# Colston Budd Rogers & Kafes Pty Ltd

**RE: QANTAS FLIGHT TRAINING CENTRE (SSD 10154)**  
**RESPONSE TO TRAFFIC MATTERS RAISED IN SUBMISSIONS**

## Site: 101 [AM EX+D - Qantas Drive - Lancastrian Drive]

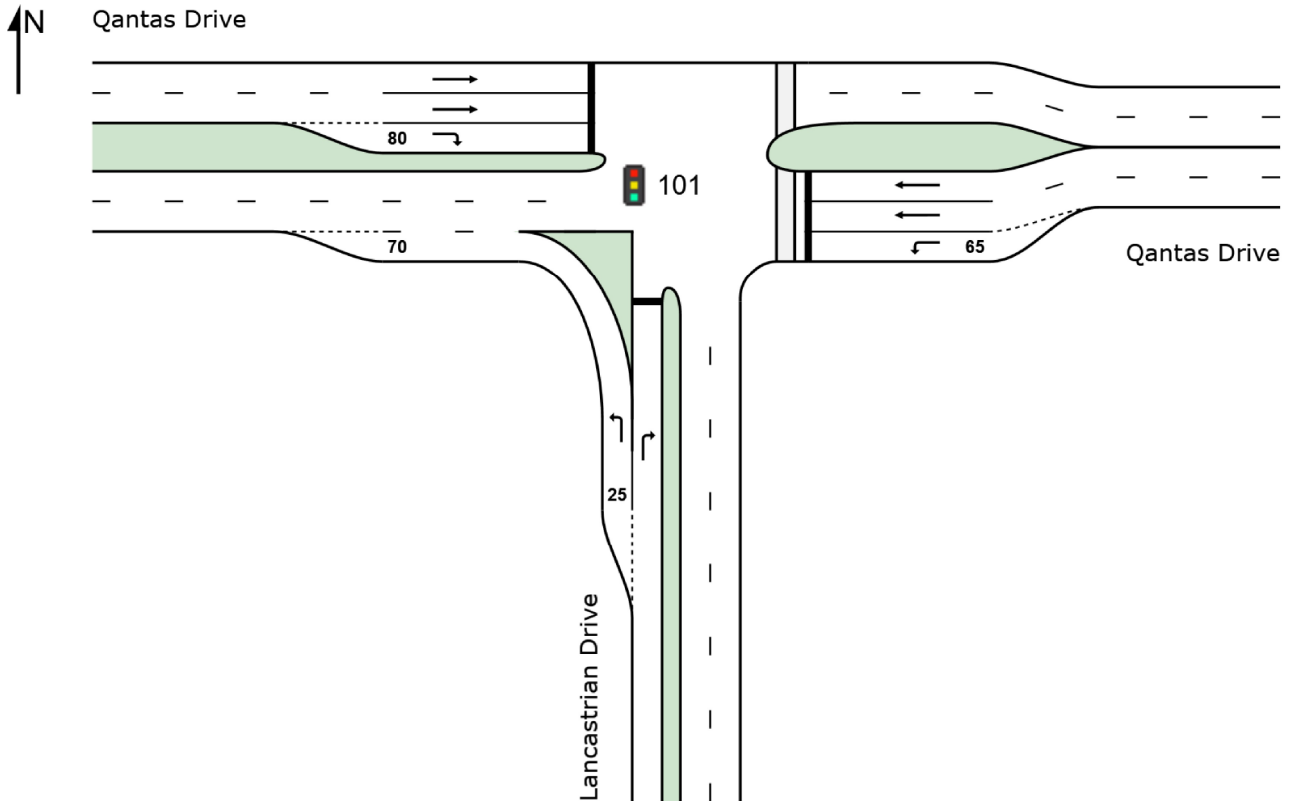
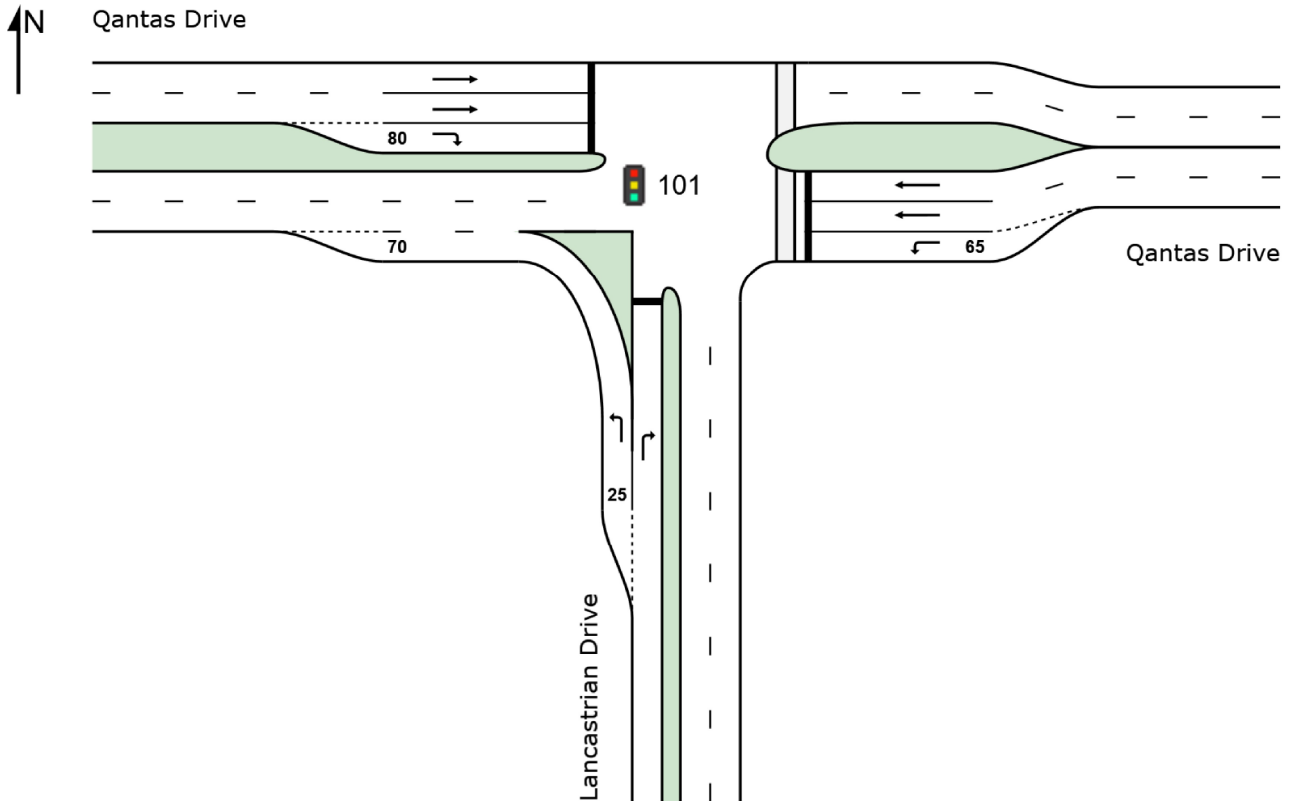
- *provision of SIDRA outputs to verify that queuing from right turn bays at the intersections at Qantas Drive/Lancaster Road and O'Riordan Street/King Street will not overflow into adjacent through lanes; and*

6. The SIDRA analysis shows that with the SSD, the right turn bays for the right turns from Qantas Drive into Lancaster Road and from O'Riordan Street into King Street (west) can accommodate the volume of right turning traffic. The 95% queue into Lancaster Road was found to be 66 metres with the right turn bay 80 metres long. The 95% queue in King Street (west) was found to be 20 metres with the right turn bay 60 metres long. SIDRA movement summaries are attached.
